2015/09/14

MVHB/HD/MA/SE MVAA-150、MVSD/SD1-180 Series Pneumatic Symbol Position Design Change Notice

i. Adding ISO Pneumatic symbol

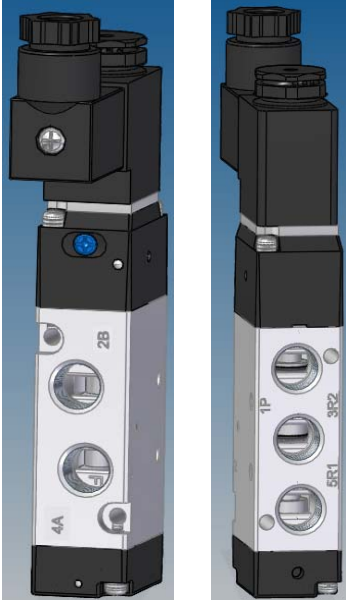
Before	After
P	1P
B	2B
R2	3R2
A	4A
R1	5R1

ii. 4A and 2B would switch the position, so do 3R1 and 5R2.
